RE: Lycee Francais Renovation
1601 Leonidas Street
New Orleans, LA 70118
Proposal # 052

Request for Information # 86

Reference: Lycee Francais School Renovation

Subject:	Status:	Response Required By:
Ceiling Heights	Please Advise	06/20/2021

01 SECOND FLOOR PLAN
1/8" = 1'-0" |

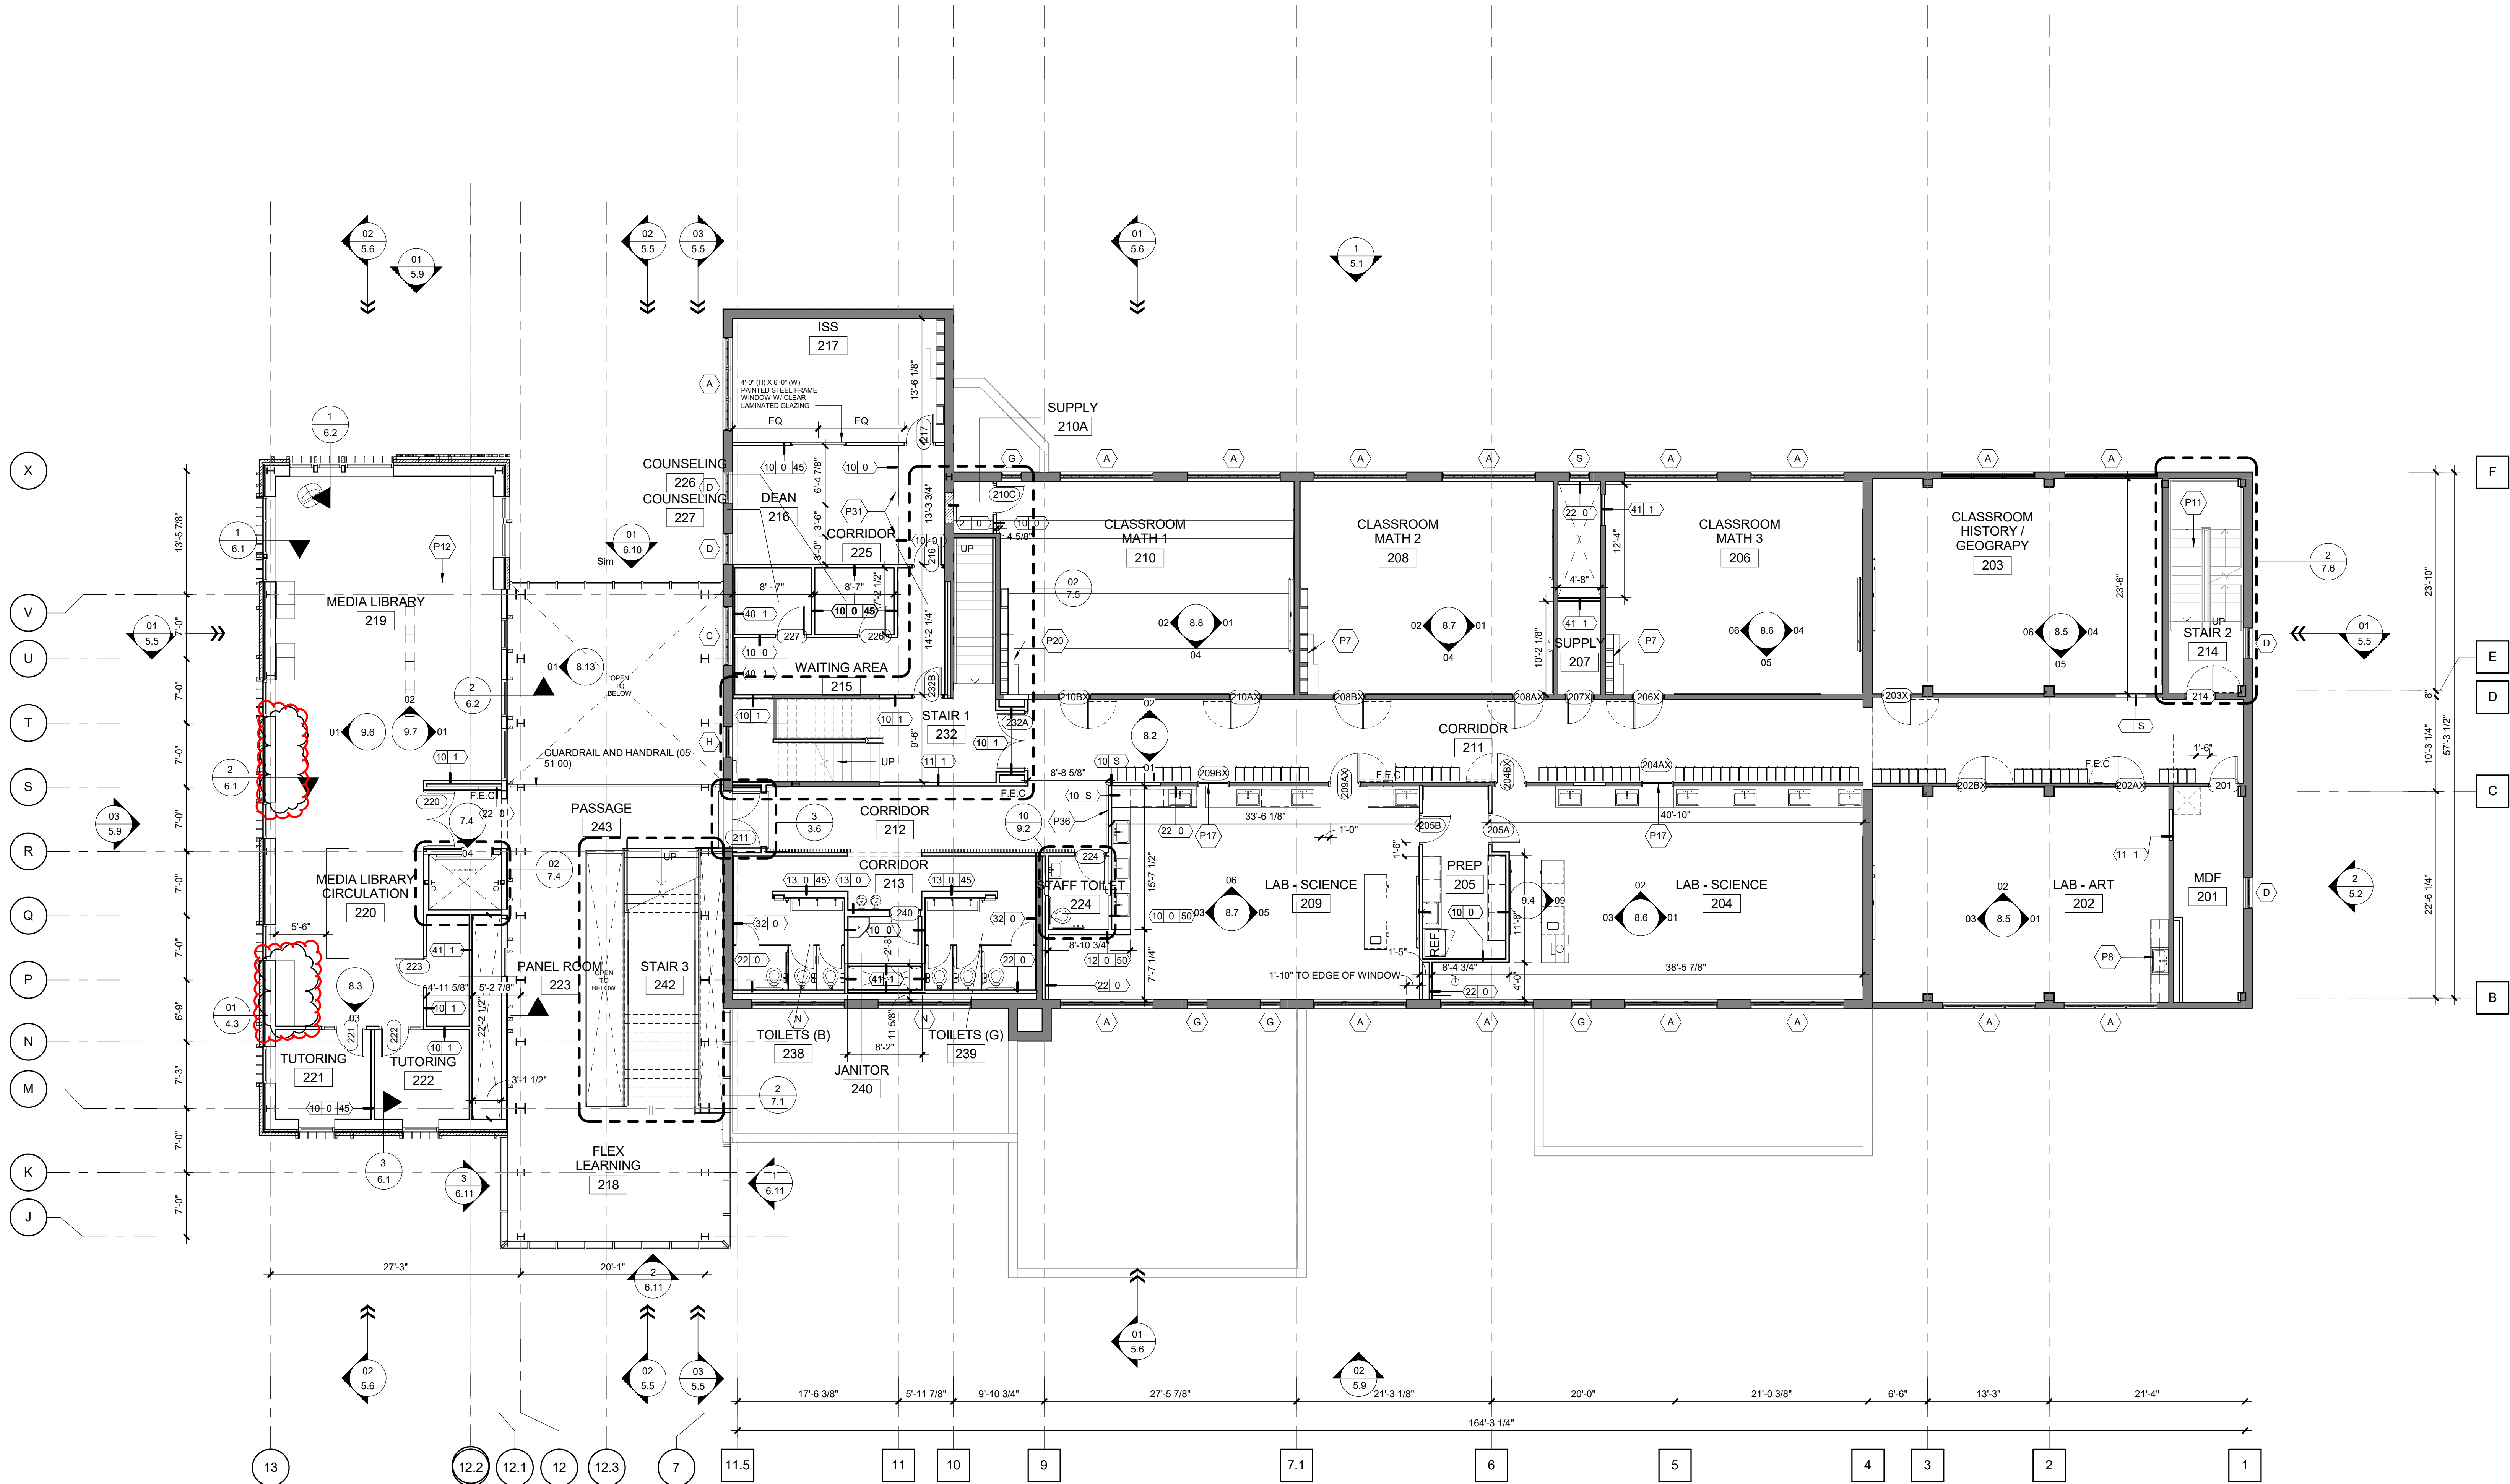
RFI Detail:
On sheet M2.1 of the mechanical plans, along column lines 12 & 13. The plans show running 2 supply ducts 24x10, 1 supply duct to feed the elevator lobby 12x20, and 1 return duct 24x10. The reflected ceiling plans show 9'-8" ceilings in that entire area from column line R to U with the bottom of the beams at 10'-5" there's not enough space to run the ductwork above the current ceiling heights. With insulation, you need a minimum of 15" of space for the 24x10 ductwork and that's not considering any other trades or lights.

See attached sheets for lowered ceilings to accommodate ductwork as manufactured. See also reductions of door frame heights, as previously discussed.
